Municipal Planning Commission AGENDA Monday, April 7, 2025 — 6:30 p.m. Bartlett City Hall Assembly Chamber

Monday, April 7, 2025 - 6:30 P.M.
Bartlett City Hall Assembly Chamber
Staff Comments

SITE PLAN

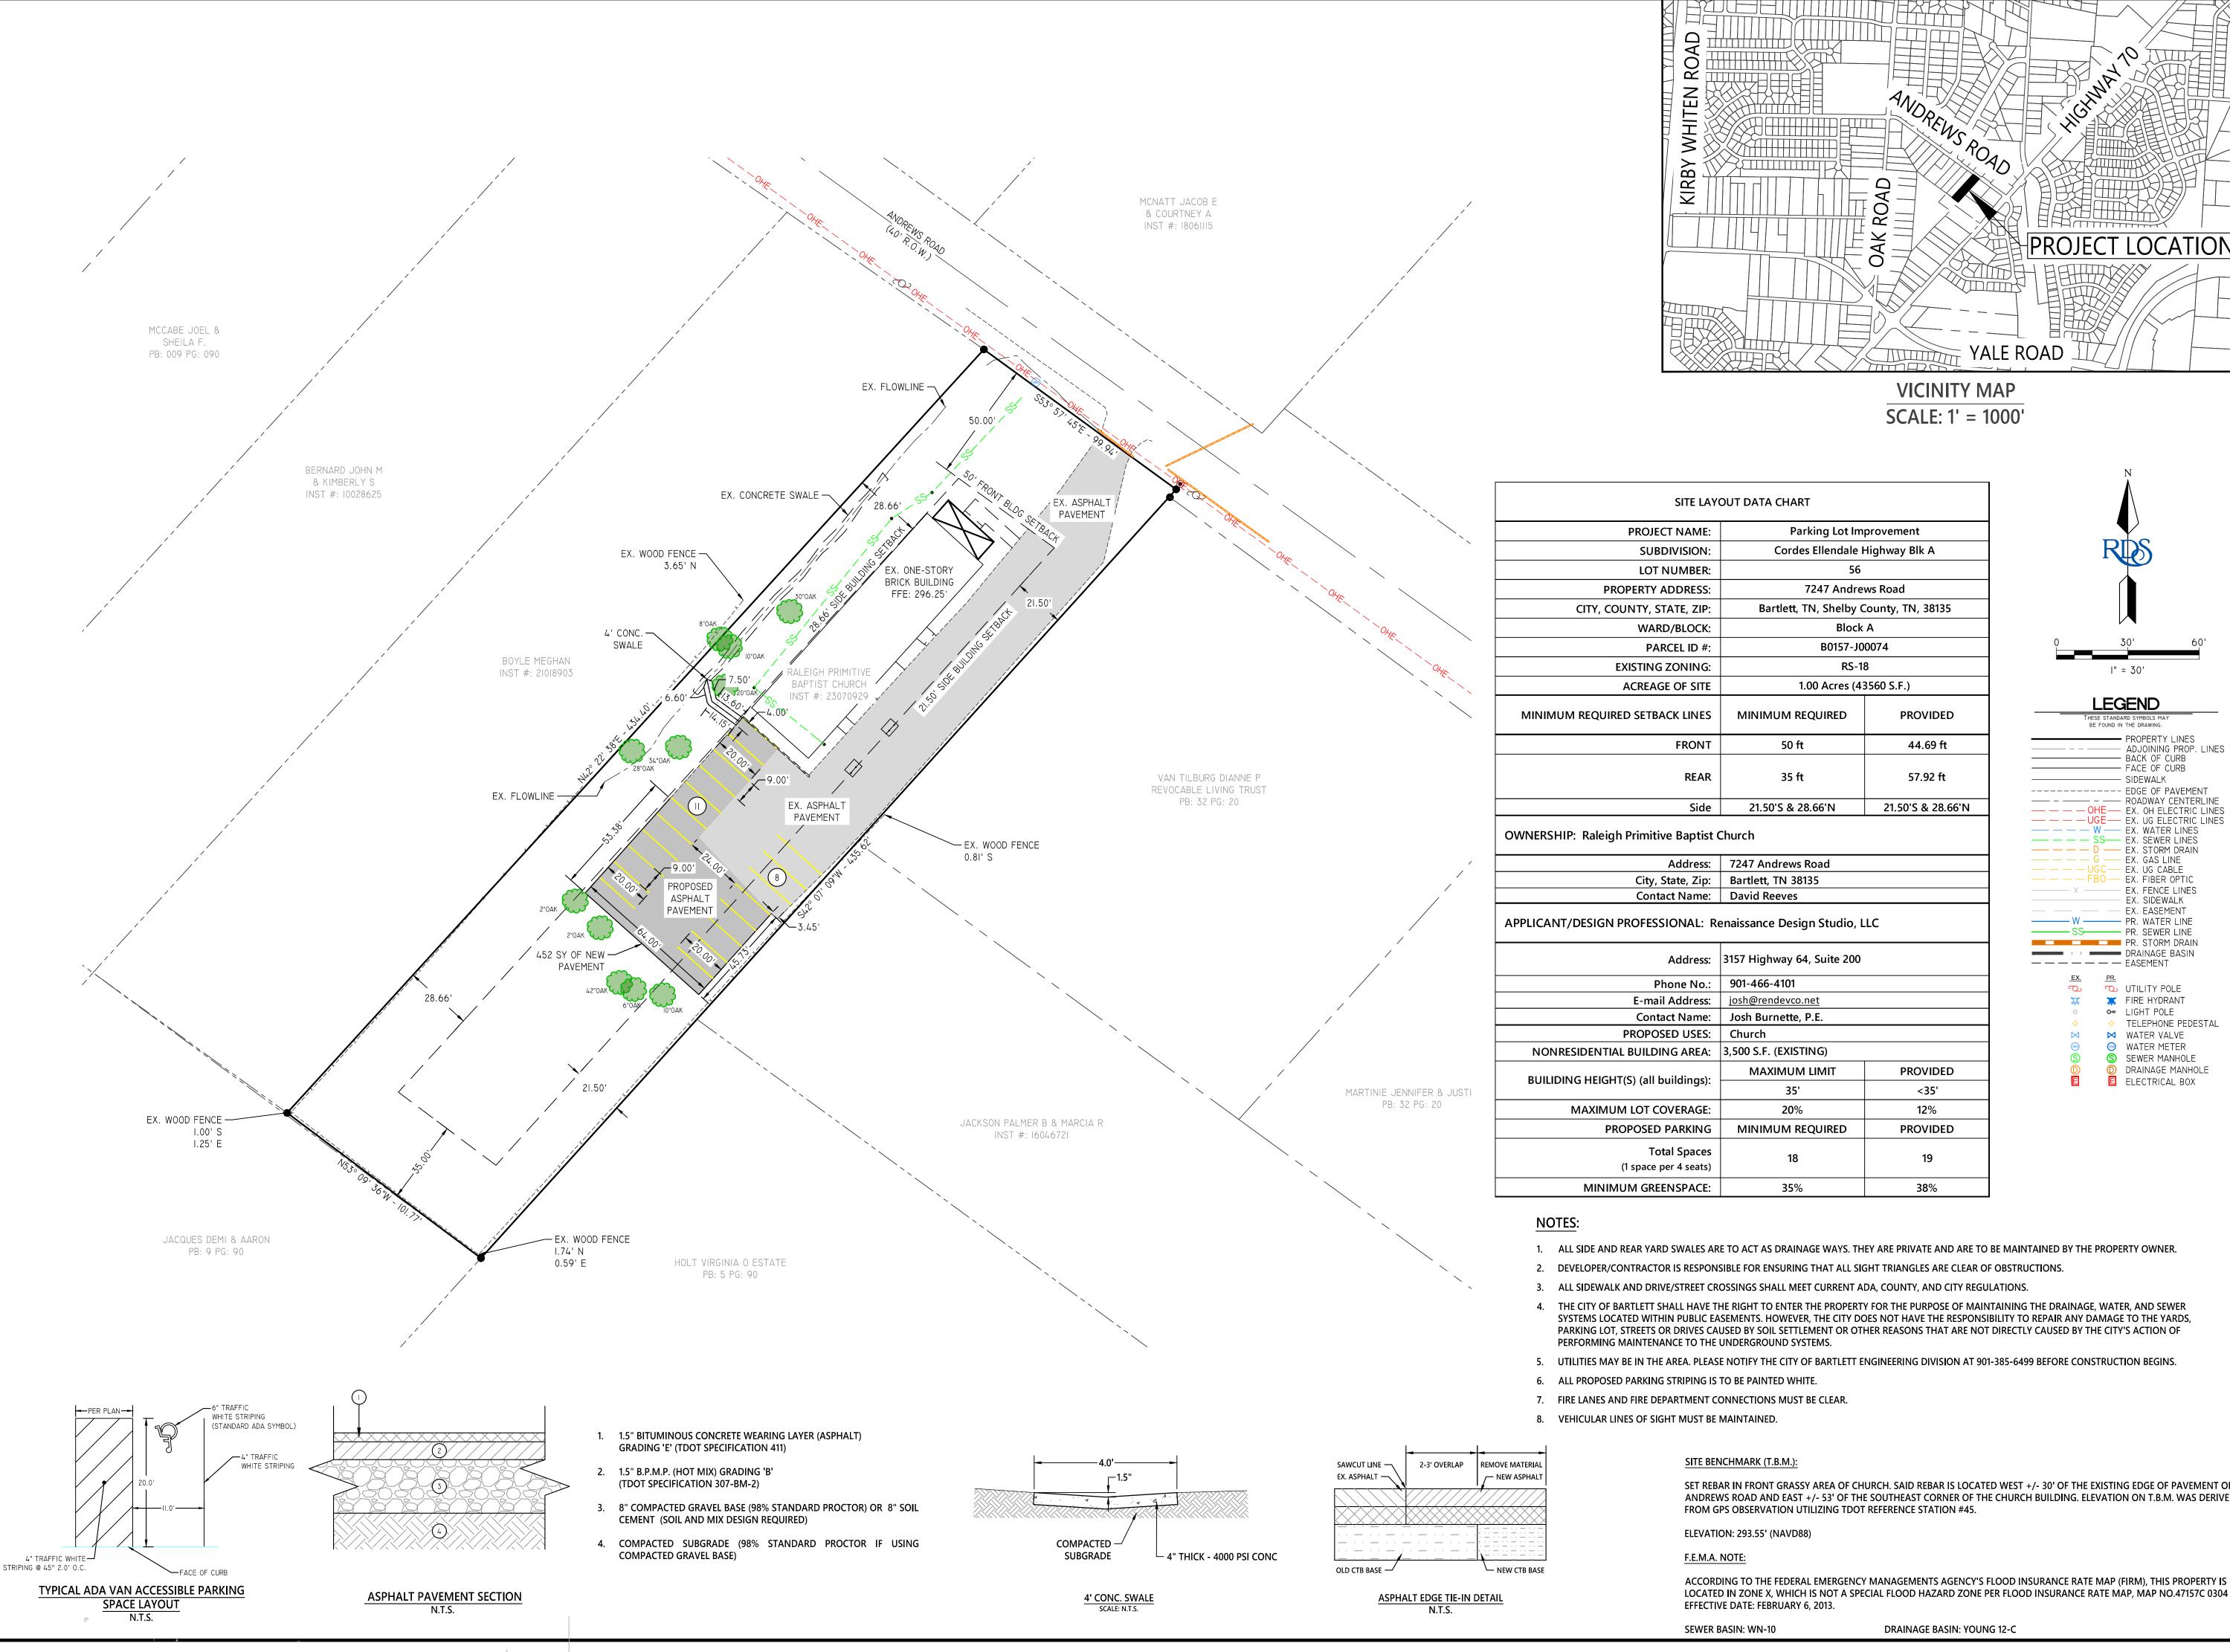
1. The pre-existing parking lot does encroach within the required 20' residential/nonresidential landscape buffer Plate 23D along the east property line. However, the applicant must revise the proposed parking layout to not encroach within the required 20' residential/nonresidential landscape buffer Plate 23D along the east property line, or the applicant must obtain a variance for this encroachment from the Board of Zoning Appeals.

- 2. The applicant must designate at least one ADA accessible parking space.
- 3. The applicant must install the Landscape Plate 23D nonresidential adjacent to residential buffer along the south, east, and west property lines.
- 4. The owner/applicant shall identify all utilities on site by contacting Tennessee One Call at 811 before commencing any site work.
- 5. The applicant and/or property owners shall be present at the meeting in order to make decisions relative to any changes that may be suggested by the Planning Commission.

GRADING & DRAINAGE PLAN

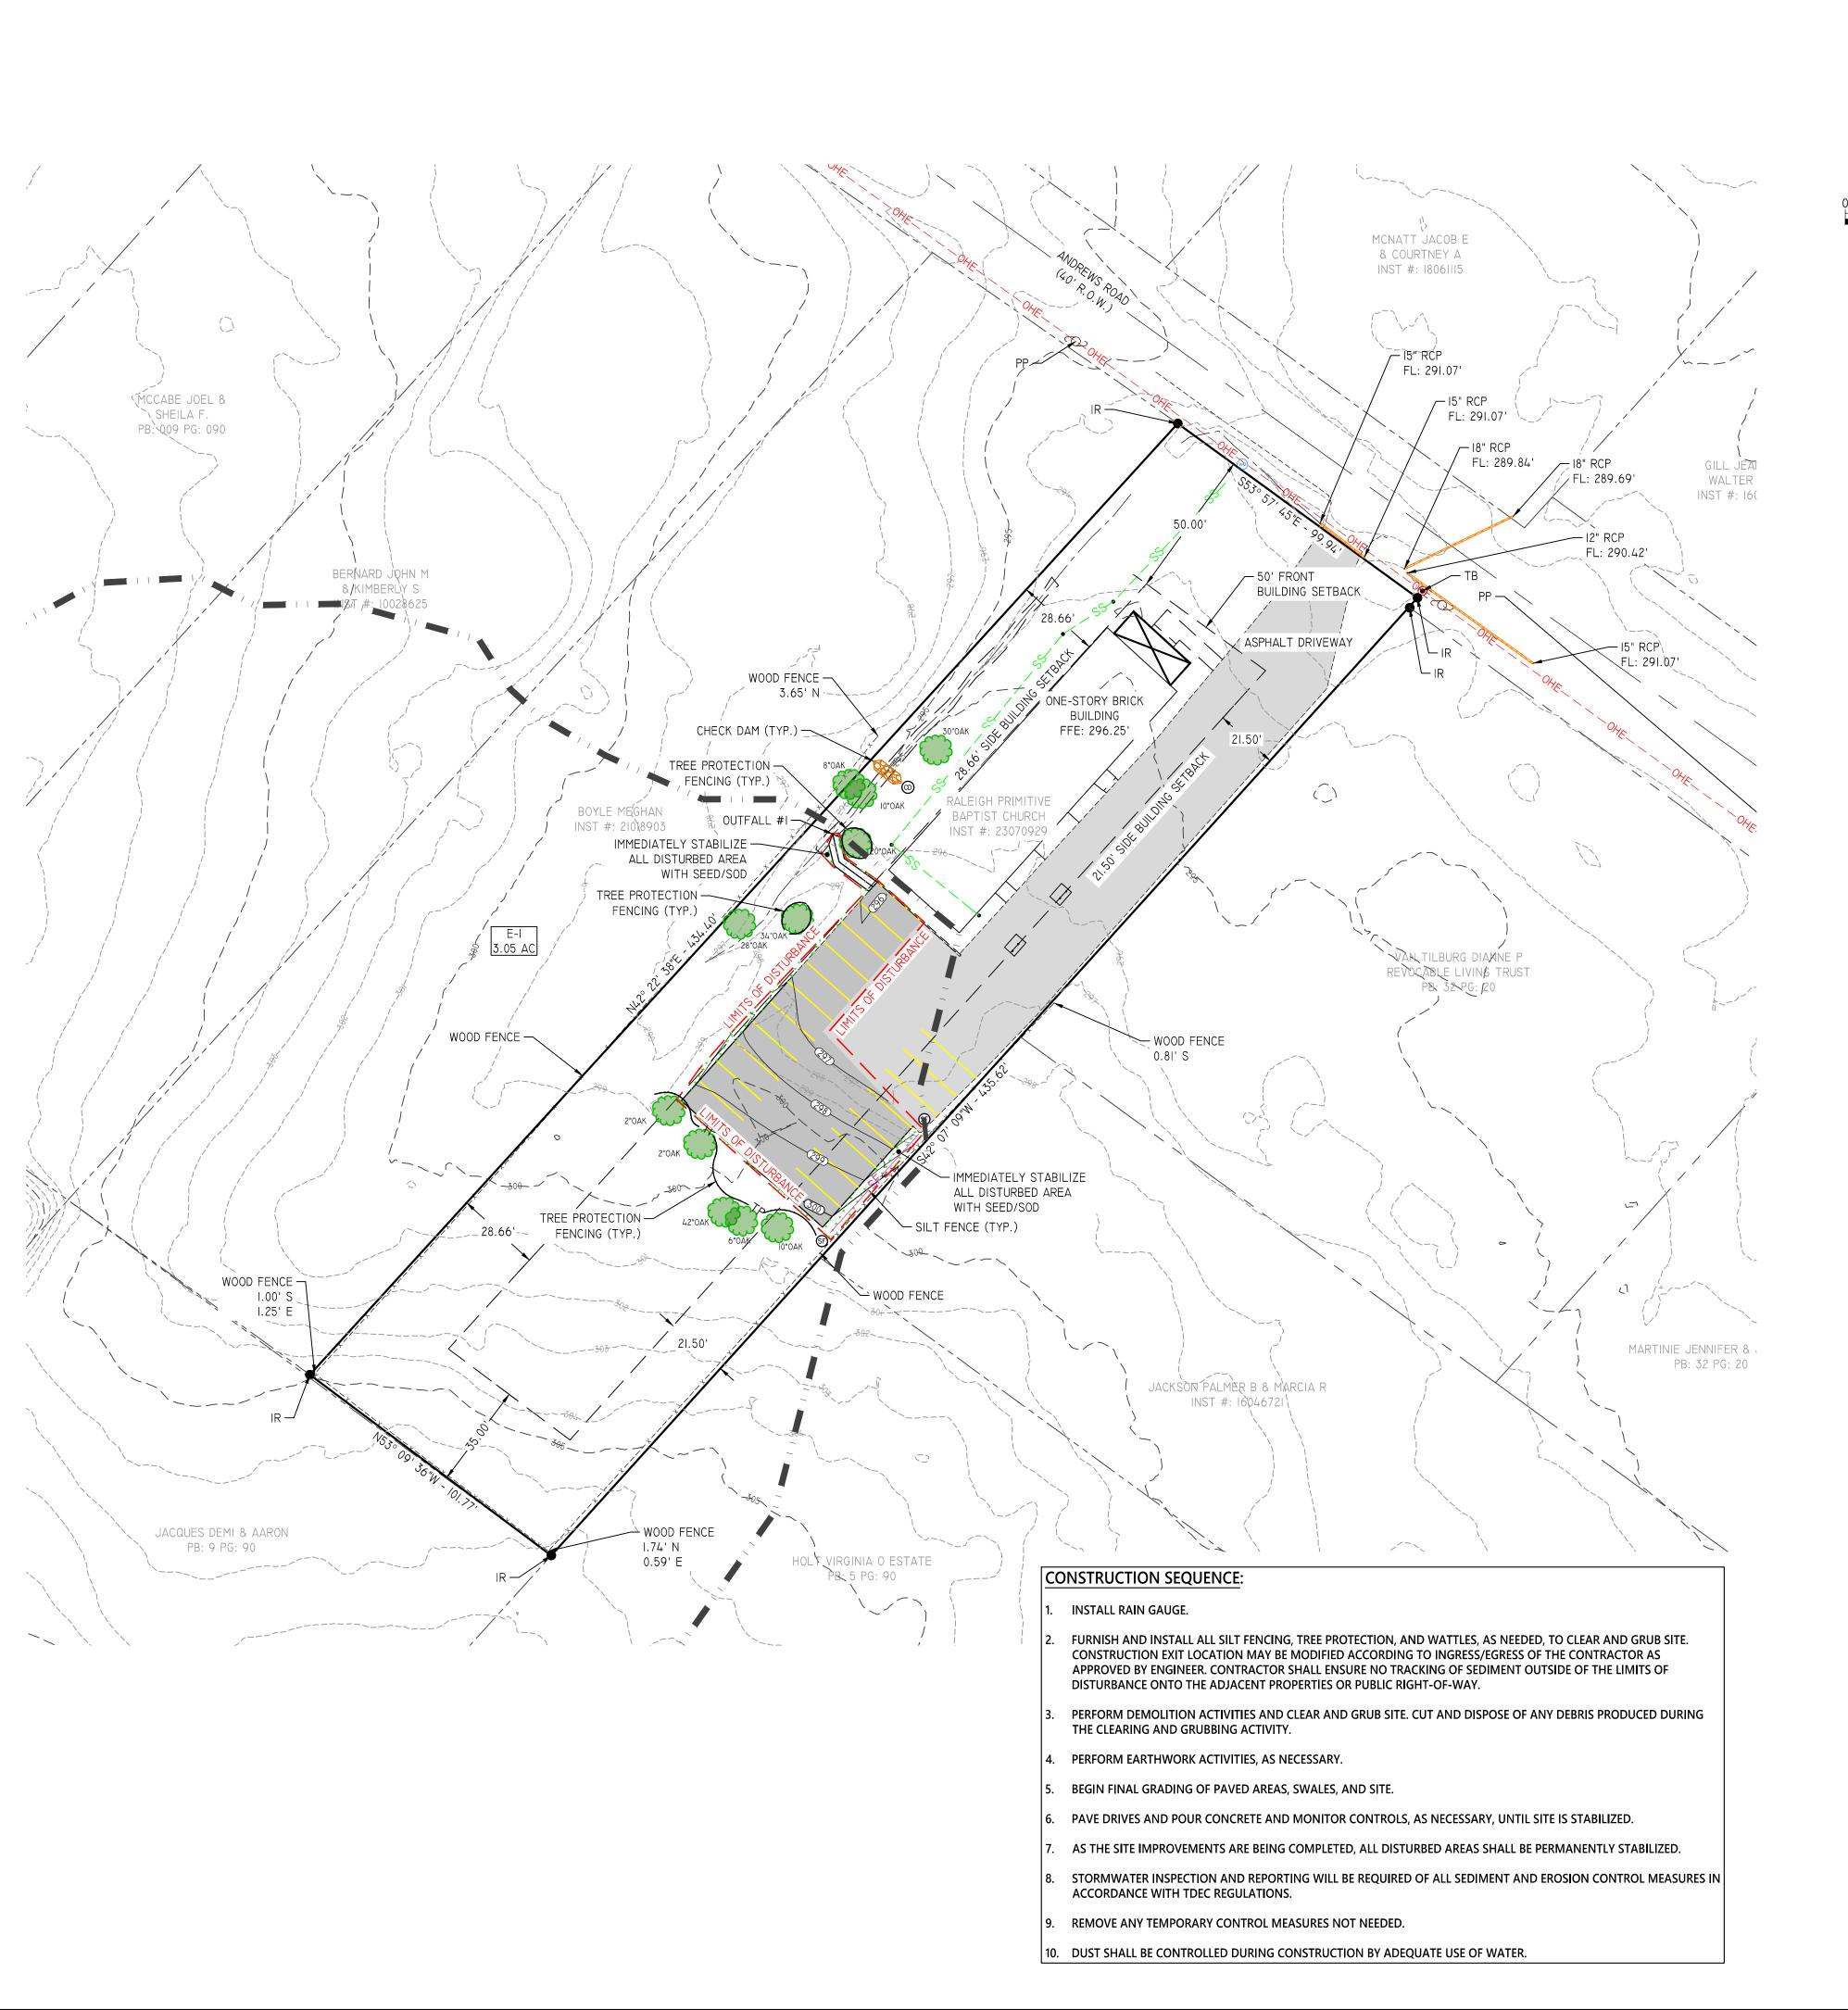
- 8. The applicant's engineer shall submit the stamped and signed detention calculations for the detention basins required for this property and show the 'pre' and the 'post' runoff for the 2, 5, 10, 25, 100 year storms.
- 9. The engineer must design the detention so that the post development runoff is equal to or less than pre-development runoff.
- 10. The detention basin area should be labeled as "Detention- no build zone" on the site plans.

EPSC PLAN

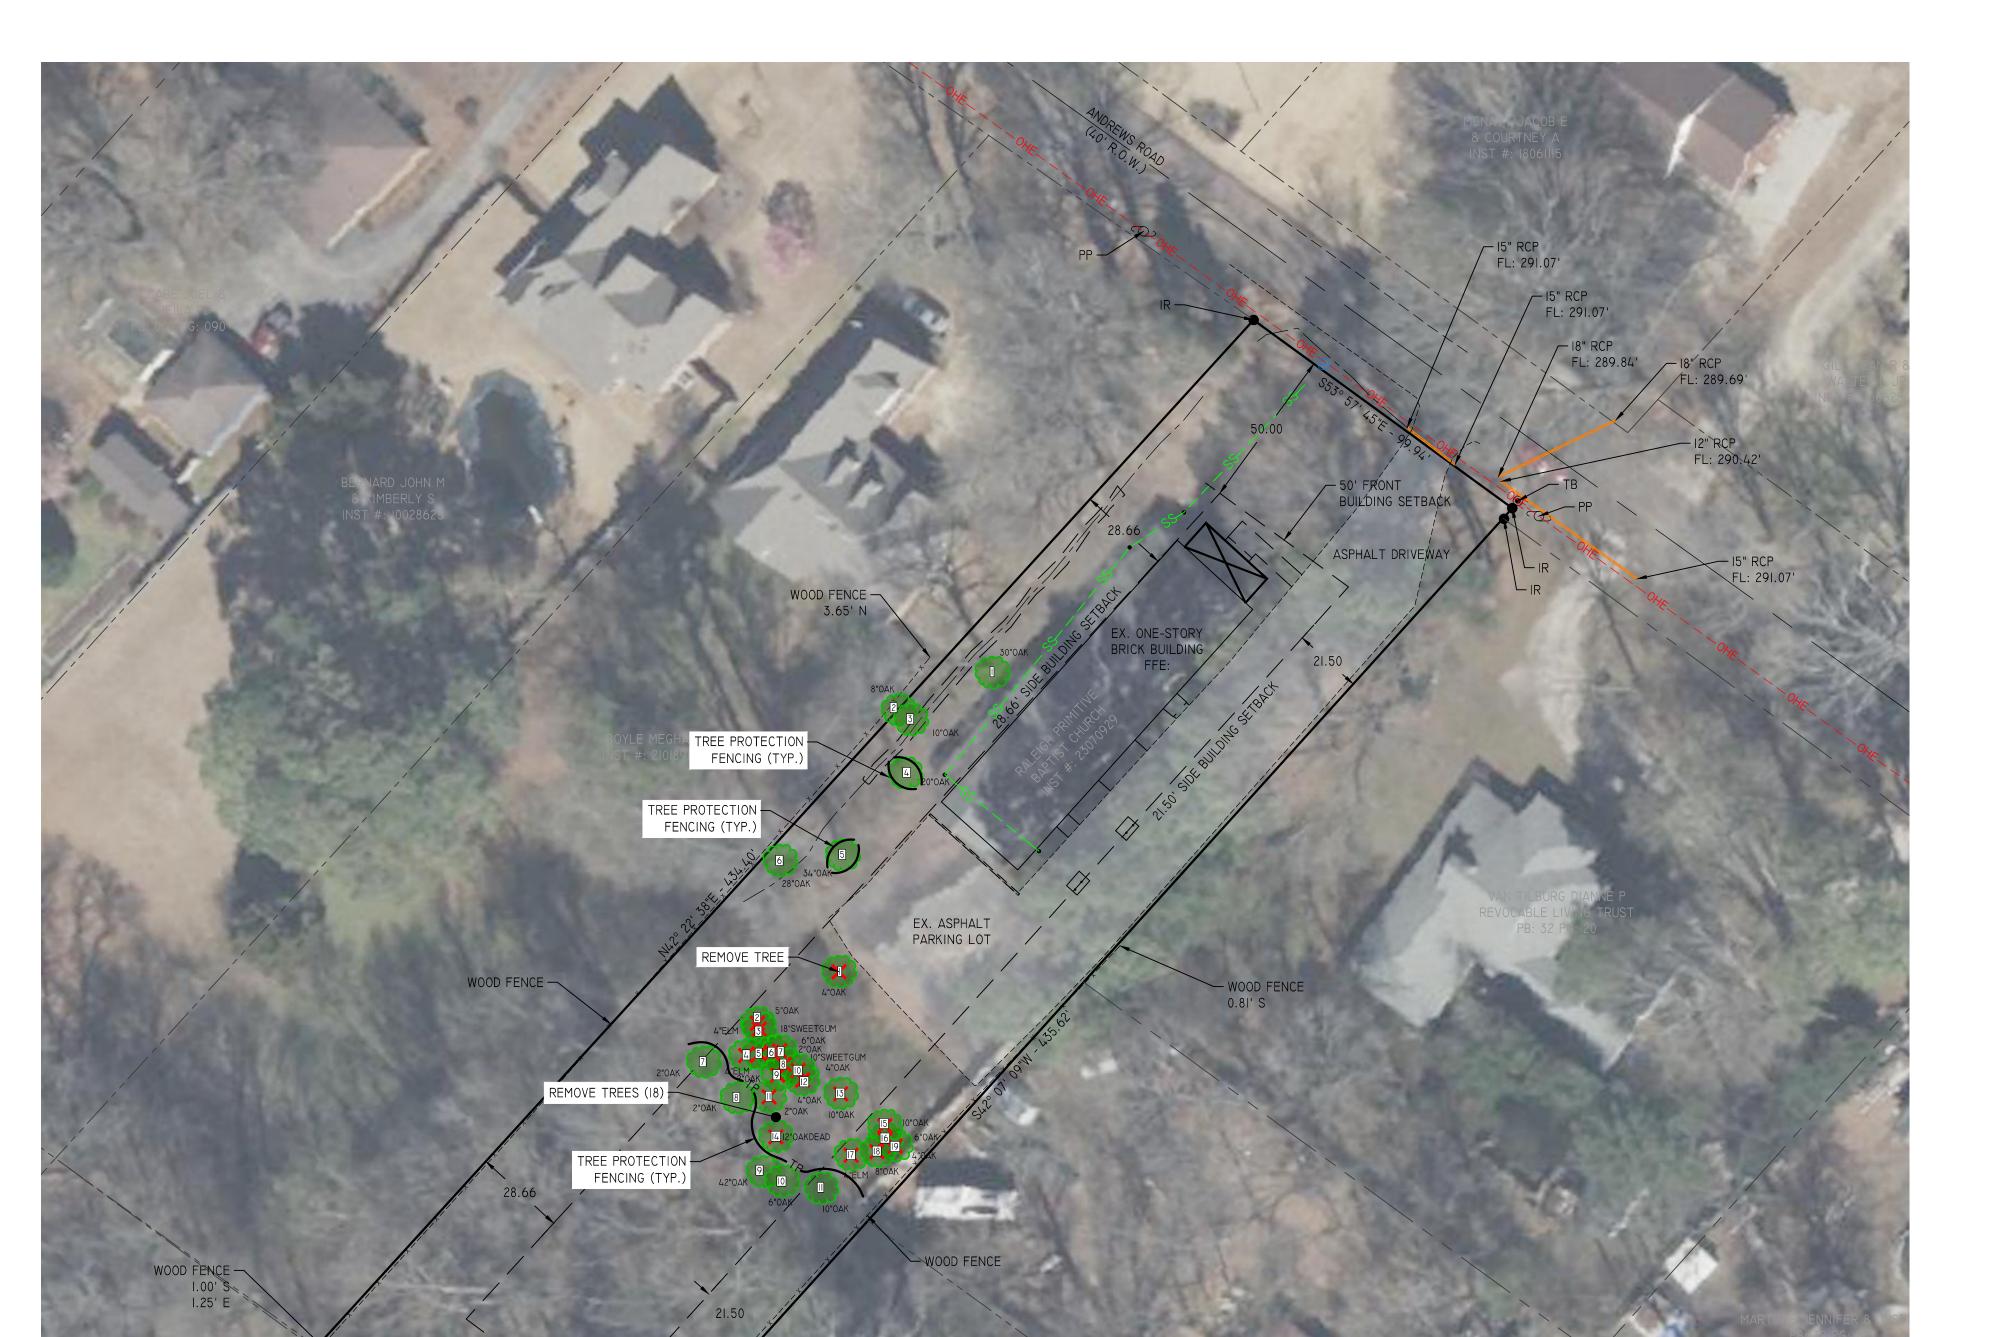
- 6. If required, the engineer shall provide a copy of the SWPPP (Storm Water Pollution Prevention Plan) that has been or will be submitted to TDEC (Tennessee Department of Conservation).
- 7. If required, prior to any work being started, an NOC (Notice of Coverage) from TDEC must be received and a copy submitted to the City of Bartlett.
